Product Safety Bulletin

Product Line: ATV

Bulletin No: 2005-2-05 (Condition A-E)

Subject: Gas Tank Leakage

Fig. 2

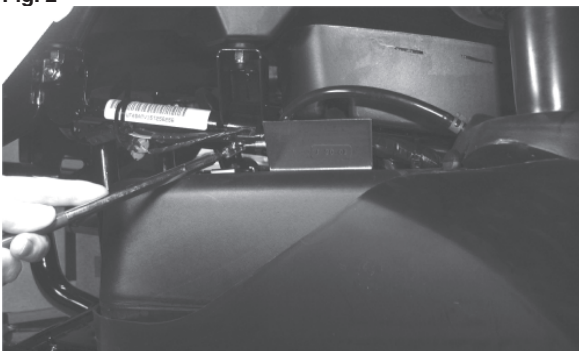
To locate the date code on the tank make sure the area near the right side of the tank is well illuminated; then locate the date code by placing a mirror at a slanted position on the top of the tank (code is located approximately two 2 in. from the outside of the tank). See Fig. 2 for positioning of mirror. See Fig. 3 for exact location of code.
